SUBJECT: Forwards response to request for addl info re review of SG tube insp & repair criteria for Unit 1.

RE: St. Lucie Unit 1
Docket No. 50-335
Steam Generator Tube Inspection
Request for Additional Information (RAI) Response

Request for Additional Information Responses

Figure 1. Predicted Burst Pressure Versus Normalized Observed Burst Pressure, PVNGS Unit 2 Pulled Tube Data.

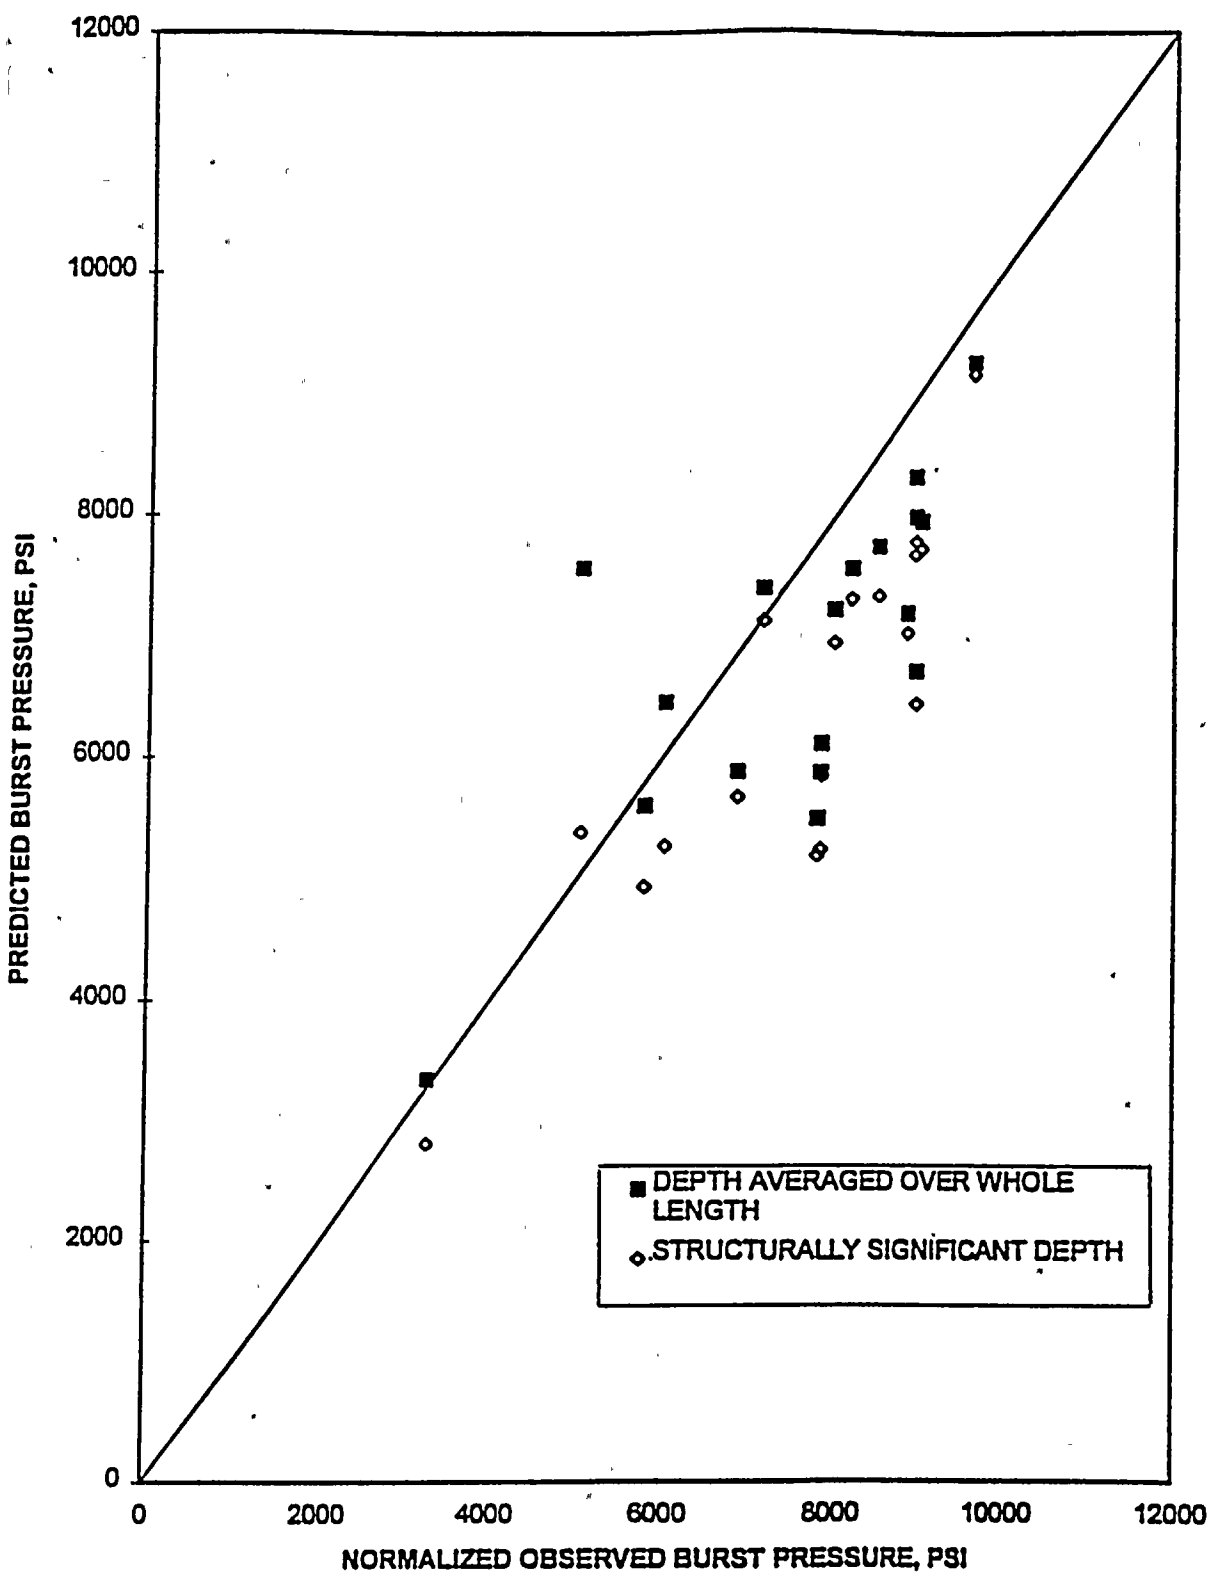
The 95/95 confidence level values for growth, NDE uncertainty, material properties, and limiting flaw sizes. For the limiting flaw sizes, the following should be submitted: (1) the limiting depth given an infinitely long indication, (2) the limiting length given a through-wall indication, and (3) the correlation relating depth and/or length to the structural integrity of the tube.

Burst pressure calculations are based on the Framatome equation using average crack depth. Attachment A Figure 1, *Predicted Burst Pressure Versus Normalized Observed Burst Pressure - PVNGS Unit 2 Pulled Tube Data*, shows pulled tube data from Palo Verde Nuclear Generating Station (PVNGS) Unit 2 supporting the use of the Framatome equation. Attachment A Figure 2, *RPC Crack Length Versus Structurally significant Crack Length - PVNGS Unit 2 Pulled Tube Data*, shows that crack length based on pancake coil eddy current data is a conservative estimate of the structurally significant crack length and Attachment A Figure 3, *Maximum Crack depth Versus Average Crack Depth - PVNGS Unit 2 Pulled tube Data*, illustrates that the structurally significant portion of the crack profile has a characteristic ratio of maximum depth to average depth. Attachment A Figure 2 and Attachment A Figure 3 are also based on pulled tube data from PVNGS Unit 2 where the operative degradation mechanism is upper bundle, axial outside diameter stress corrosion cracking/intergranular attack (ODSCC/IGA).

PSL-1 DISTRIBUTION OF INDICATION MAXIMUM DEPTHS

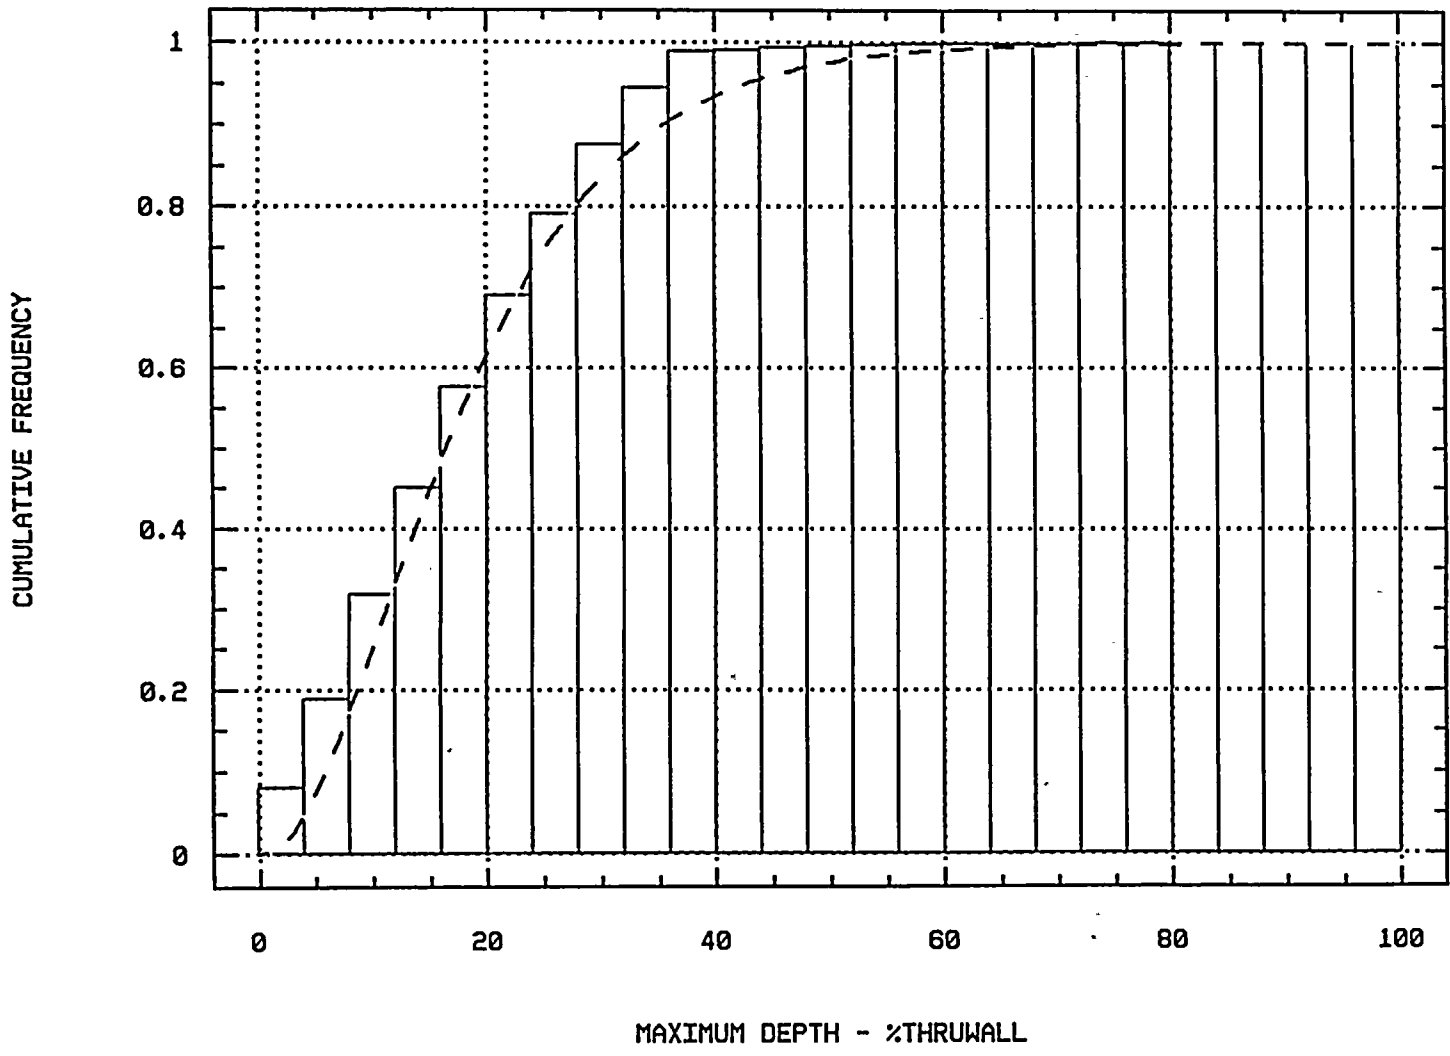
The distribution of indications detected (length and depth, as appropriate), the distribution of growth rates (length and depth, as appropriate), the distribution of NDE uncertainty (length and depth, as appropriate).

The distribution of defects for St. Lucie Unit 1 is given in Attachment B Figure 1, *PSL-1 Distribution of Indication Maximum Depths*. The data is from bobbin coil inspection during the current refueling outage (SL1-14) and consists of more than 17000 data points from both steam generators. The upper 95 percent probability/confidence value for this data is less than 40 percent through wall.
